Request for Additional Information
Model No. Traveller
Docket No. 71-9297

By application dated April 1, 2004, Westinghouse Electric Company requested a Certificate of Compliance for the Model No. Traveller package. This request identifies additional information needed by the Nuclear Regulatory Commission staff (the staff) in connection with its review of the safety analysis report (SAR). The requested information is listed by chapter number and title in the SAR. NUREG-1609, "Standard Review Plan for Transportation Packages for Radioactive Material," was used for this review. This request describes information needed by the staff for it to complete its review of the SAR and to determine whether the applicant has demonstrated compliance with regulatory requirements.

Figure 2-91 Predicted and Measured Y Accelerations

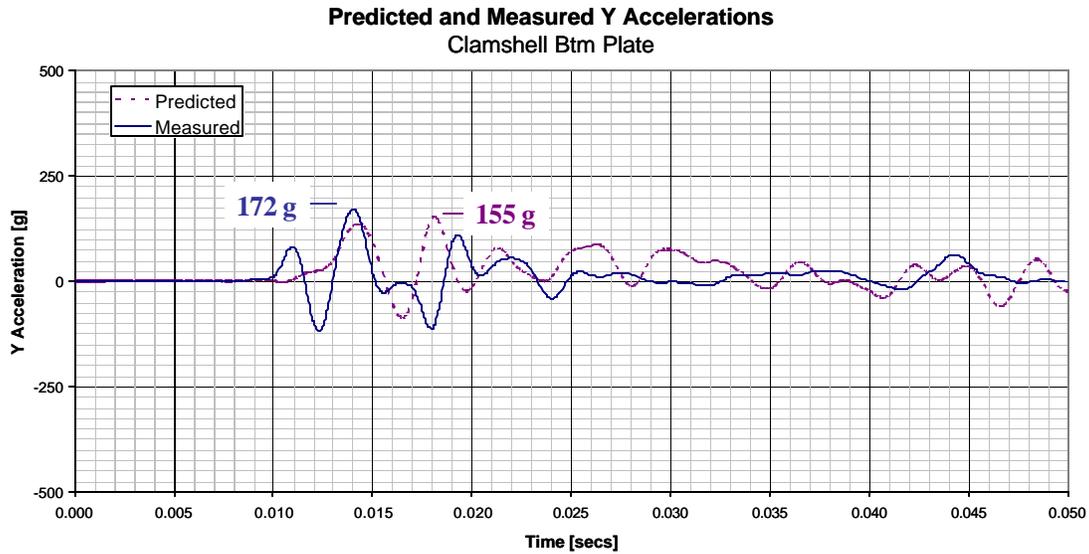
- 2-27 Provide a discussion explaining the apparent discrepancy between the measured vertical decelerations of 191 g in Table 2-30 and 205 g in Figure 2-91.

The following figure, Figure 2-91, has been replaced:

Figure 2-129 Drop Orientation for QTU Test Series 1

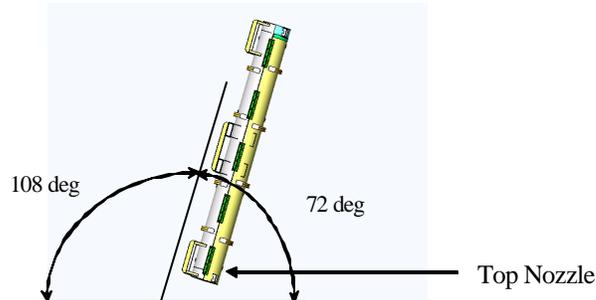
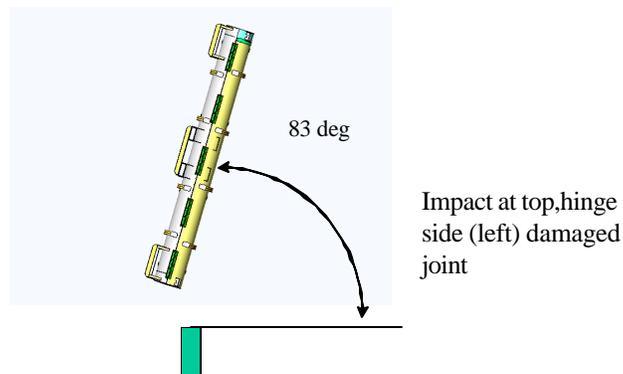
2-28 Provide a discussion clarifying the drop angle/orientation depictions of Test 1.2 and Test 1.3 in Figure 2-129 for the respective CG-Over-Corner and pin puncture tests. It is not clear how the drop angle of 108° was defined for Test 1.2. The puncture drop of Test 1.3 does not appear to have the package hinge side of the Outerpack land on the puncture pin as described in the text.

The following text has been added to Section 2.12.4.2.1 and Figure 2-129 has been replaced:

A pitch angle of 72 degrees was measured along the outerpack surface for Test 1.2. The angle of 108 degrees should be located as shown in Figure 2-129. The reference to “hinge side” in Test 1.3 indicates the package side that pivots, rather than the actual hinge. The impact point of Test 1.3 (Figure 2-132) was on the top nozzle end and on the pivot (left) side of the package.

Figure 3-27A Orientation of CTU for Thermal Test

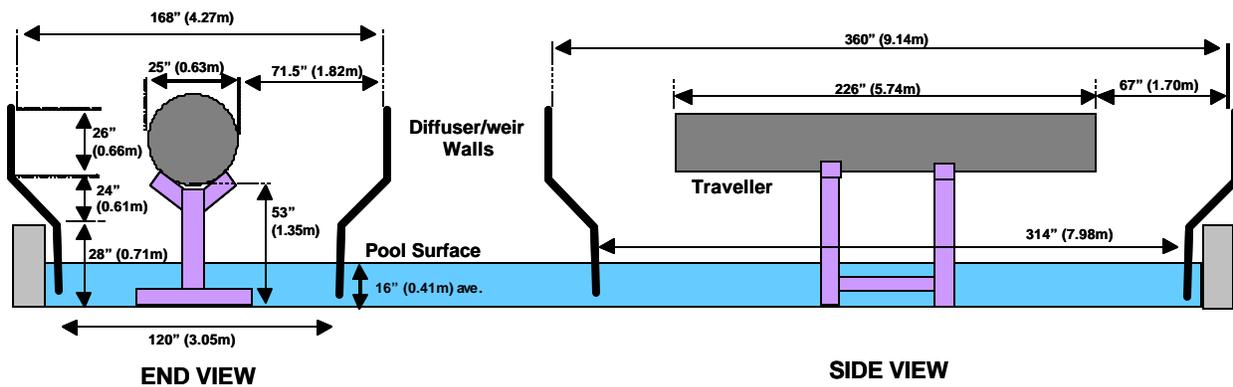
- 3-1 Revise the SAR to specify the orientation of the certified test unit (CTU) with regard to the fire test pool. Specifically, state the distance the bottom of the package was positioned above the fire pool surface and the distance the pool extended beyond the ends of the package.

Figure 3-27A shows the orientation of the Certification Test Unit (CTU) for the thermal test. The bottom of the package was positioned approximately 1 meter from the top of the fire pool surface. The distance of the outer facility walls beyond the edge of the package were 67" at the ends and 71.5" at the sides.
